**PLAN COMMISSION AGENDA ITEM EXECUTIVE SUMMARY**

<b>Project Title/ Address:</b>	<b>Bucki Single Family Subdivision</b>
<b>City Staff:</b>	Matthew O'Rourke, Planner

**STAFF REPORT**

**RE:** Bucki Single-Family Subdivision

# PRELIMINARY PLAN FOR BUCKI PROPERTY

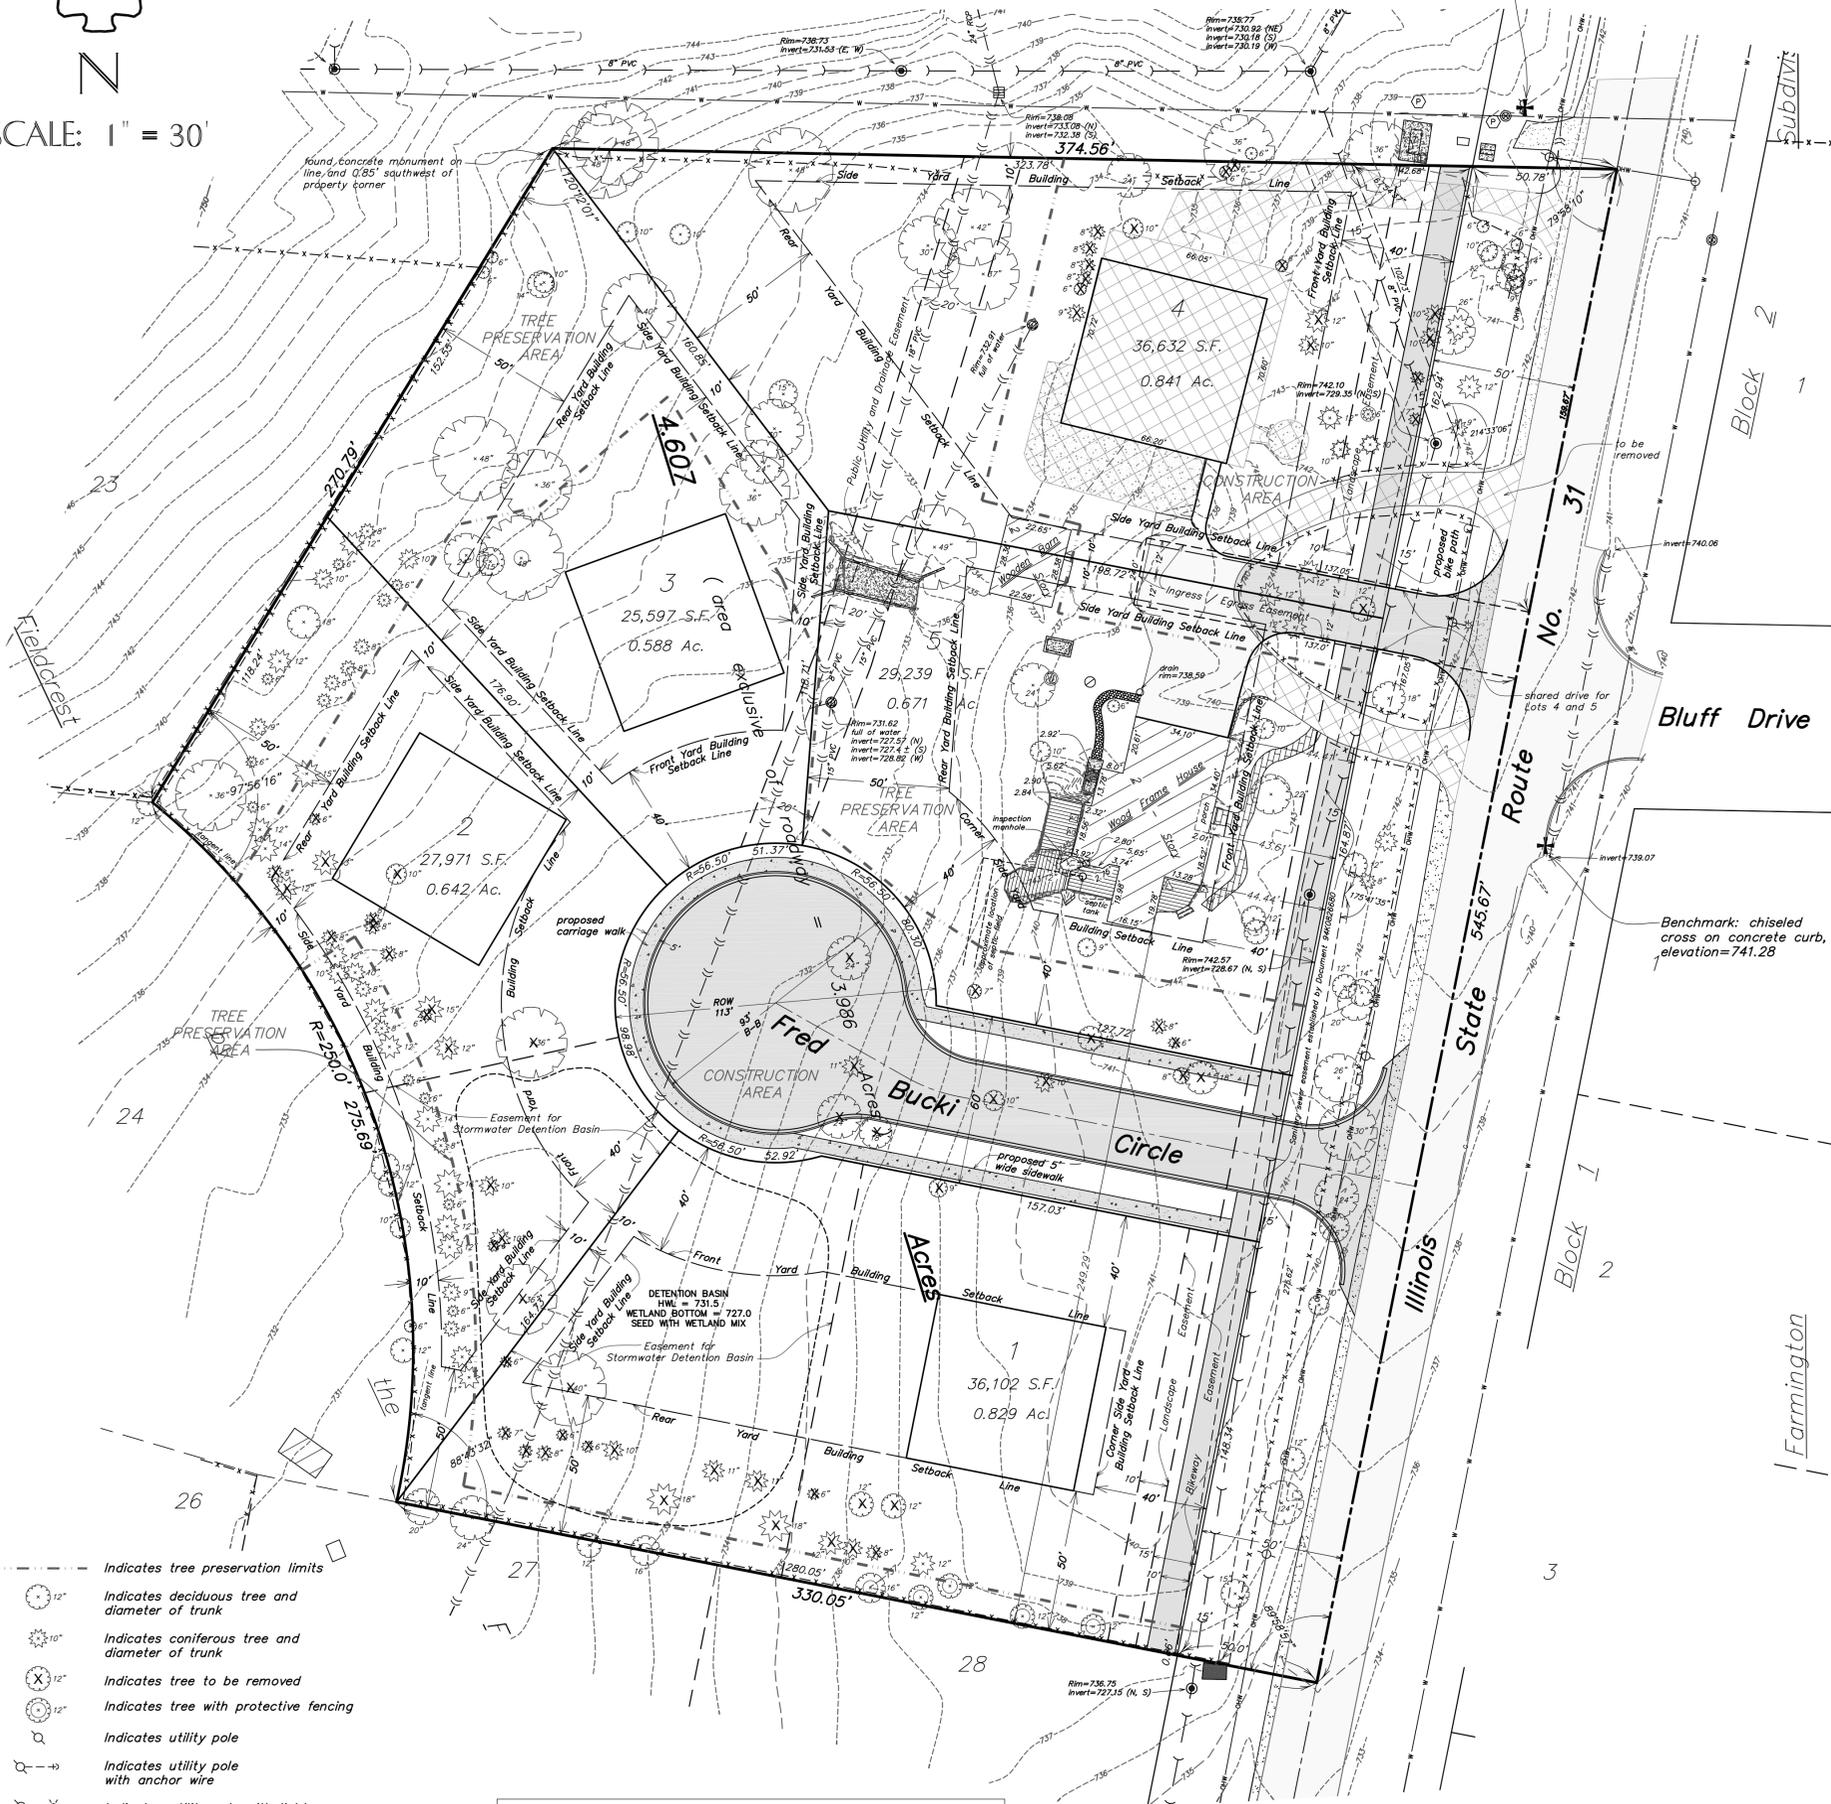
1. Please more detail how the off-site tributary flow will pass through the site.
  - Calculate off-site tributary flows for the 10 year and 100 year events.
  - Calculate and depict 10 and 100 year WSEL's at:
    - North property line
    - Lot 3
    - Cul-de-sac pavement
  - Provide cross sections and easements to verify the route will remain unobstructed.
  - Verify low opening freeboard.

2. There is an area at the north end of the property that appears to include hydrophytic vegetation and may be a wetland. Please provide a full Tab 4 Wetland Submittal which includes a wetland delineation and a narrative addressing Sections 414-418, 502, and 1500 of the Kane County Stormwater Management Ordinance as administered by the City of St. Charles.

1. Refine the off-site tributary area based on subdivision plans and stormwater management reports for The Reserve of St. Charles and River's Edge.
2. Please define the overland overflow weir from the detention basin and provide calculations to size the weir.
3. The restrictor should be sized for the total tributary area including off-site. Please see attached Kane County Memorandum for restrictor sizing. The capacity of the downstream storm sewer shall be taken into consideration.
4. A Stormwater Permit Fee will be required with submittal of final plans.
